APPLICATION NO.	FILING DATE	FIRST NAMED INVENTOR	ATTORNEY DOCKET NO.	CONFIRMATION NO.
09/847,605	05/01/2001	Karl Jacob Haltiner JR.	DP-302846	7187

Office Action Summary	Application No. 09/847,605	Applicant(s) HALTINER ET AL.	
	Examiner Raymond Alejandro	Art Unit 1745

This office action is in response to the amendment filed on 09/22/03. The applicants have overcome the objections, and the 35 USC 112 rejection. However, the 35 USC 102 rejection and the 35 USC 103 rejections still stand for the reasons of record. Thus, the claims are finally rejected.

The instant application is directed to an interconnect for fuel cell elements wherein the disclosed inventive concept comprises the particular flow passage configuration.

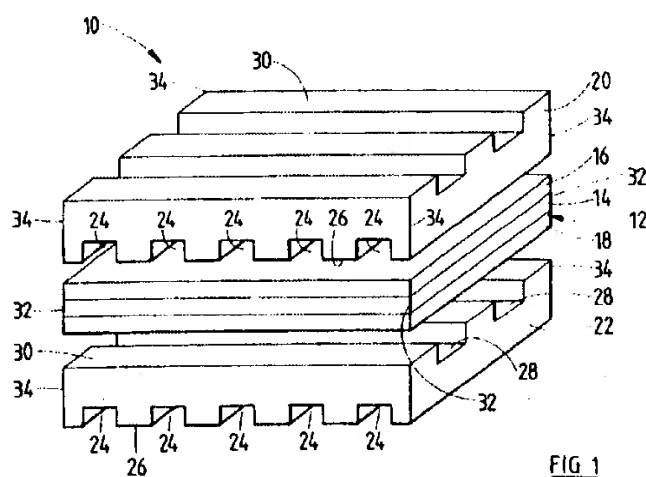
Figure 1 above illustrates a fuel cell assembly 10, the assembly comprises a fuel cell 12 comprising a solid oxide electrolyte central layer 14 with an anode layer 16 overlying one face of the electrolyte and a cathode layer 18 overlying the opposite face of the electrolyte. The fuel is sandwiched between a pair of interconnects 20, 22 which in use are in face contact with the anode 16 and cathode 18, respectively.

Figure 1 above depicts interconnects 20, 22 comprising gas flow channels 24 and 28. As can be appreciated from Figure 1, the interconnect comprises a plurality of top side surfaces 30 and underside surfaces 26 closely spaced to each other which act as contact points between the interconnect and electrode and wherein said top side surfaces 30 and underside surfaces 26 have small dimensional diameters. It is noted that the term "diameter" has been construed as the

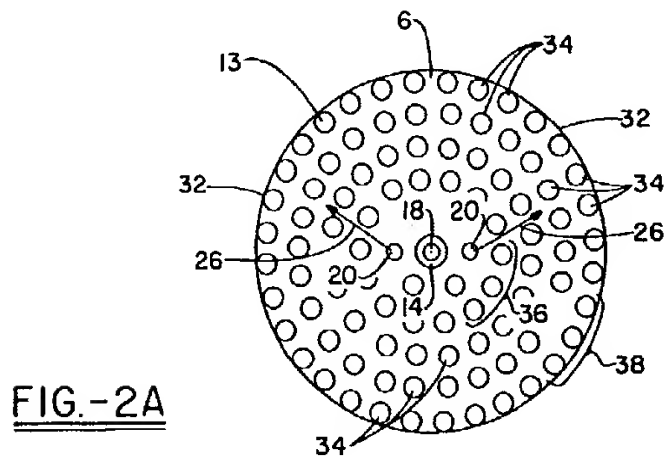
Figure 2A below shows a separator 6 defining microchannels 26 on either or both of its surfaces. Since the separators contact the anode and cathode surfaces, microchannels 26 defined within the separator surfaces provide reactant channeling (col 6, lines 33-40). A microchannel 26 may be defined by a quantity of regularly spaced circular columns 34 (*contact points*) extending between surfaces (col 6, lines 45-48). It is disclosed that it should be understood that a preferred pattern of columns 34 would utilize many more columns than shown, with each column having a diameter on the order of about 1 mm or less (col 6, lines 58-61/col 7, lines 48-52). The cell and

stack diameters are typically about 50 to about 80 mm (col 5, lines 10-12). The specific contact point density is apparent upon inspection of the separator plate 6 as illustrated in Figure 2A.

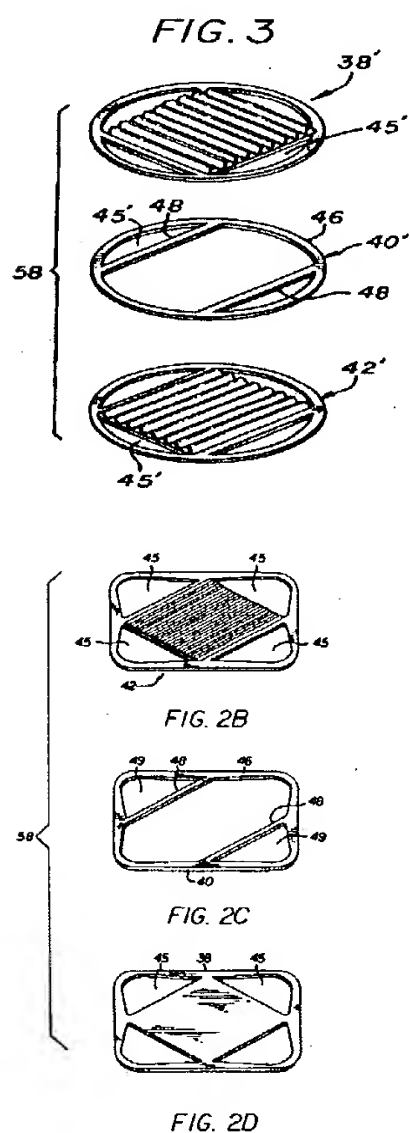
In view of the above, it would have been obvious to one skilled in the art at the time the invention was made to make the contact points on the interconnect of Badwal et al by having the specific contact point density, shape and diameter of Ruhl et al because Ruhl et al teach that flow channel dimension, shape and contact percentage can be customized and controlled through the channel design for enhancing reactant distribution of the cell. Accordingly, those of ordinary skill in the art would find motivation to make the specified contact point density in the interconnect of Badwal as it is evident from Ruhl et al's teaching that a preferred pattern of columns would utilize many more columns than shown in the simplified figure (see col 6, lines 58-60). Thus, the preferred pattern may be designed to control flow distribution within a cell by defining pathways that offer reduced resistance in comparison with the surrounding material wherein the flow distribution may be further controlled by the number, size or arrangement of the micro-channels within the cell. The preferred pattern is designed with consideration to the column spacing and the contact area percentage. Further, those of ordinary skill in the art would find motivation to make the specific contact point shape in the interconnect of Badwal et al as Ruhl et al teaches that columns (contact point) of different geometries may be utilized to provide customized flow characteristics so that reactant gas flowing through the shaped channel achieves tailored local flow, pressure and velocity distributions. Moreover, those of ordinary skill in the art would have motivation to make the specified contact point diameter in the interconnect of Badwal et al as Ruhl et al disclose that the preferred pattern utilizes column having the specific diameter which help to minimize the cell pressure drop, to achieve a good gas velocity, thereby

preventing the surrounding gas mixture from diffusion backward into the cell. Accordingly, the diameter of the columns and their contact area percentage would be selected as a compromise between minimizing electrical resistance, achieving good reactant gas distribution to and from the active electrode sites, achieving the target pressure drop with a minimum pattern thickness and fabrication limitations.
